Subdivision Lampite Park PD- Final Plat/Plan

Date 5 Oct 77 Item # 70-77

Preliminary Review Agencies Comments

Lamp Lite Park

LAMP LITE PARK FILING NO. ONE

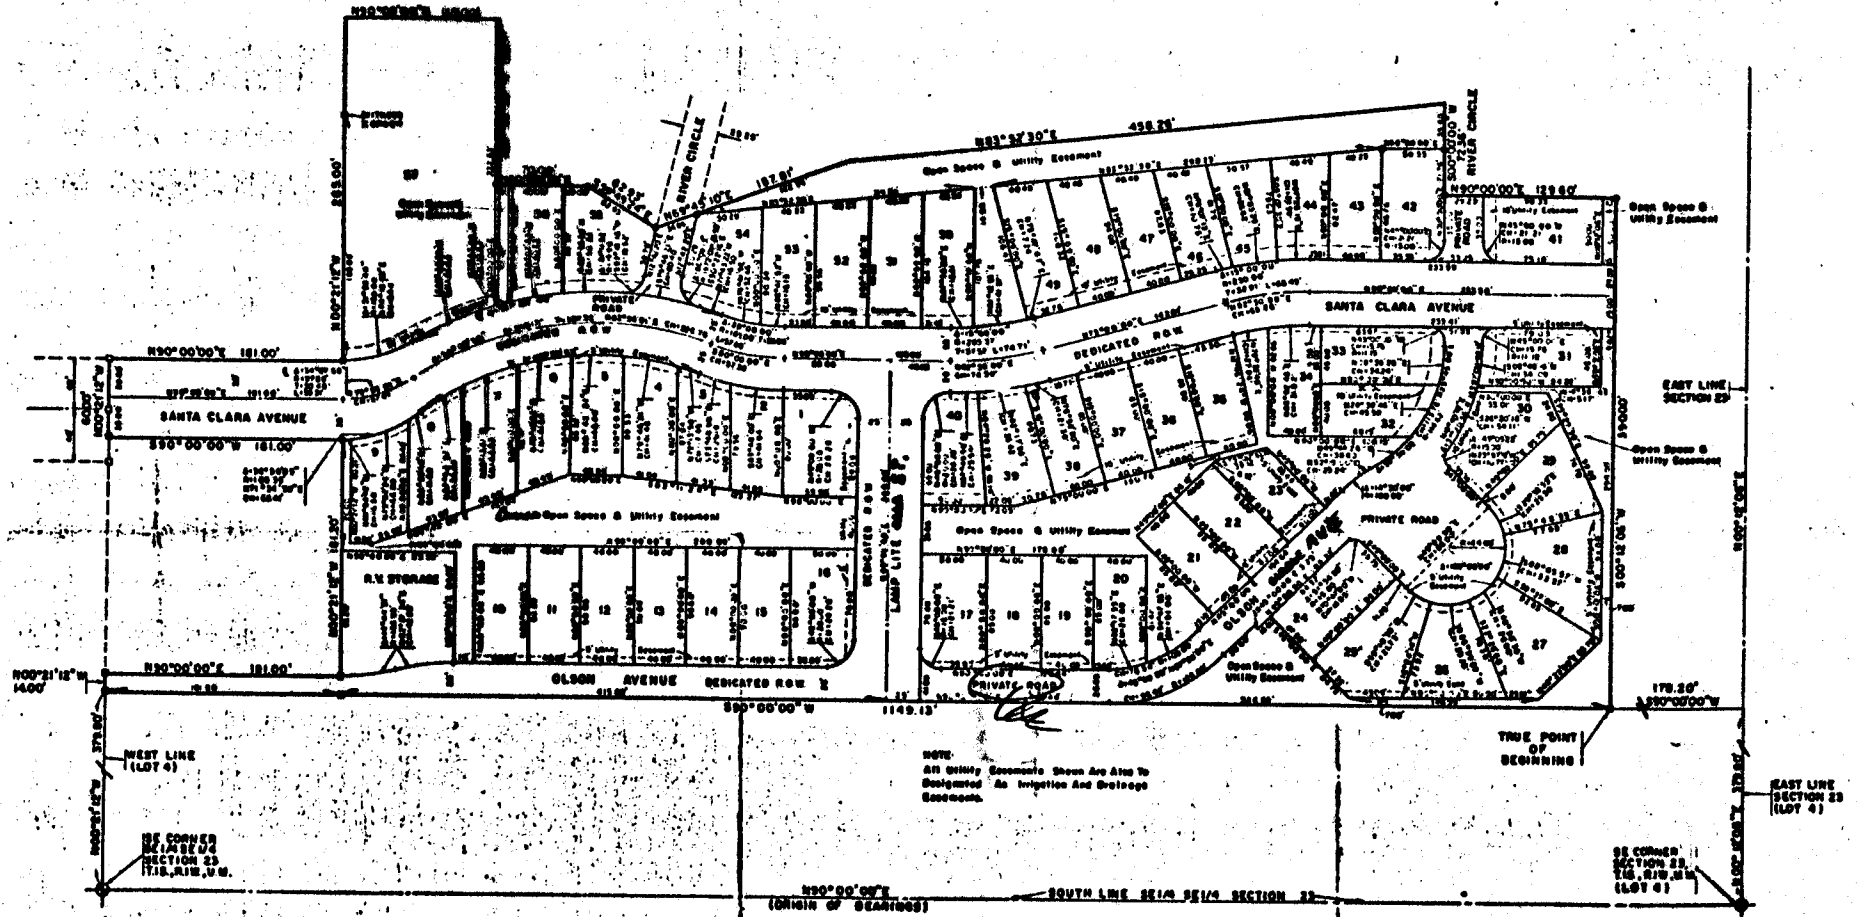
- 1) Require a statement from ~~Bob Staloff~~ or the geologist addressing stabilization of units built on the edge of the scarp.
- 2) Present utilities composite shows insufficient hydrants & water line sizes. Prior to recording plat a revised utilities composite must be filed with the development department showing hydrants & waterline sizes as required by city specs. with signatures of appropriate agencies indicating approval. (as per final plat reqs.)

- 3) City Engineer needs specs. on handling irrigation system. This should be included on final utilities composite/roadway plan.
- 4) City specs. require verticle face curbs on all public streets.

- 5) On Olson Ave, construct 6' curbwalk & 19' matt with a Temporary "undedicated" Turn around where recreational vehicle storage will be located when street is fully improved.

- 6) Require sidewalks **on** all street frontages in this filing. with single walkway through open space connecting with pedestrian access to school.
- 7) Final plat must contain statement that engineered foundation **shall** be submitted on all lots as required by building department.
